Item Name: Replacement Skidtube

DESIGN		DART AEROSPACE LTD HAWKESBURY, ONTARIO, CANADA
DRAWN	RF	
CHECKED		DRAWING NO. REV. E
MFG. APPR.		D2580 SHEET 1 OF 8
APPROVED		TITLE SCALE
DE APPR.		205 SKIDTUBE ASSEMBLY NTS
DATE	11.06.21

DRAWING NO.	TITLE	REV. E	DART AEROSPACE LTD ENGINEERING ORDER	D.E.O. NO.	SHEET NO.	SCALE
D2580	205 SKIDTUBE ASSEMBLY			D2580-E-1	SHEET 1 OF 1	NTS

PURPOSE:
CHANGE ALL C'BORED WELDED CROSSBOLT SPACERS TO SWAGED SPACERS

SECTION B-B, F-F, I-I
NOT TO SCALE

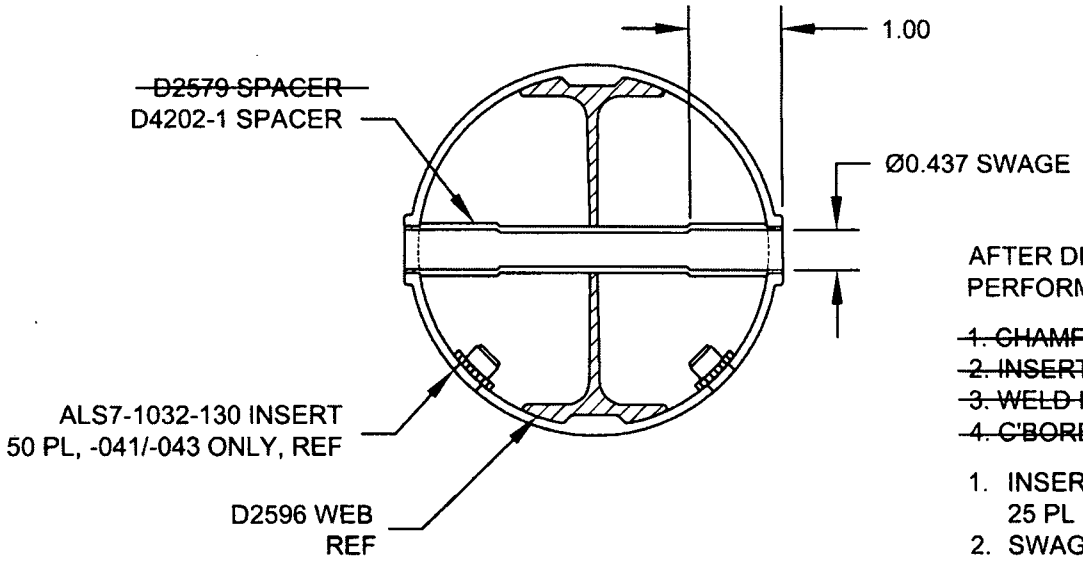
CHANGE:
PARTS LIST IS AMENDED AS FOLLOWS:

4		* D2579	CROSS BOLT SPACER
20	20	25	D4202-1	SPACER

SECTION B-B, SECTION F-F, & SECTION I-I ARE AMENDED AS FOLLOWS
FOR ALL HOLES THAT WERE ORIGINALLY C'BORED:

*** FOR -045 SKIDTUBE ONLY:**
WEL D 4X D2579 SPACERS PER DWG
IN LOCATIONS MARKED "**NO C'BORE**".
REF SHEET 4 OF DWG.
